33ha, accessible only from the top, along Hawkins Hill Road (a private RoW).

328 Hawkins Hill Road Non Renumerated, Gradual and Ongoing Appropriation of Opportunity by WCC

328 Hawkins Hill Road Farfield Chokepoint

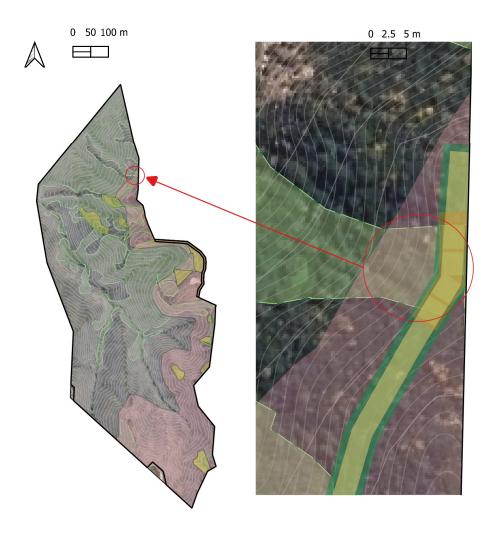
The issue is that SNA overlay appears incorrect.

Firstly, it's over an existing legacy track, so the regrowth was exotic scrub (gorse), so it's hard to understand why it would have been considered Significant.

Second, the gorse has since been cleared, as is apparent in current satelite photos, so the overaly is either based on incorrect data, or...

Third, considering the current discussions regarding the use of the land, it actually seems strategically placed as although very small, it cuts off vehicular access to somewhere between 5ha and 10ha of land.

328 Hawkins Hill Road Faraway Chokepoint

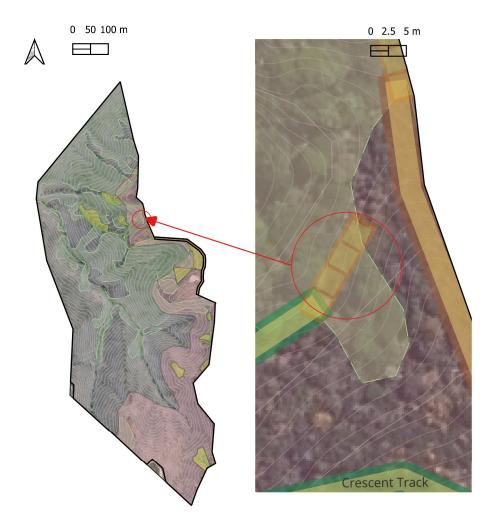
The issue is that SNA overlay appears incorrect.

Firstly, it's over an existing legacy track, still visible in 2016, so the regrowth was exotic scrub (gorse), so it's hard to understand why it would have been considered Significant.

Second, the gorse has since been cleared, as is apparent in current satelite photos, so the overaly is either based on incorrect data, or...

Third, considering the current discussions regarding the use of the land, it actually seems strategically placed as although very small, it cuts off vehicular access.
